Re: Application for Official Plan Amendment, Zoning By-law Amendment, Draft Plan of Subdivision, Draft Plan of Condominium and Site Plan
336 King Street East
Part of Lot 8, Concession 7 (ALB)
Files: POPA 18-03, RZ 18-08, 21T-18003C, 21CDM-18001C & SPA 18-088

Planning staff deemed the above noted applications complete on December 10, 2018 and circulated the submission to commenting departments and agencies for review. To date, planning staff have received the comments provided below and/or attached on the following submission materials:

1000 1800mm HT. WOOD PRIVACY SCREEN

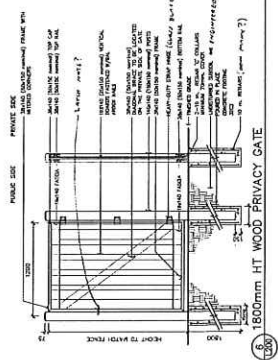
→ IS WOOD PRIVACY SCREEN IN LAYOUT IF YES, PLEASE CONSIDER THIS APPLICATION.
→ ALL VENTILATION AND AIR FLOW TO BE CONSIDERED.
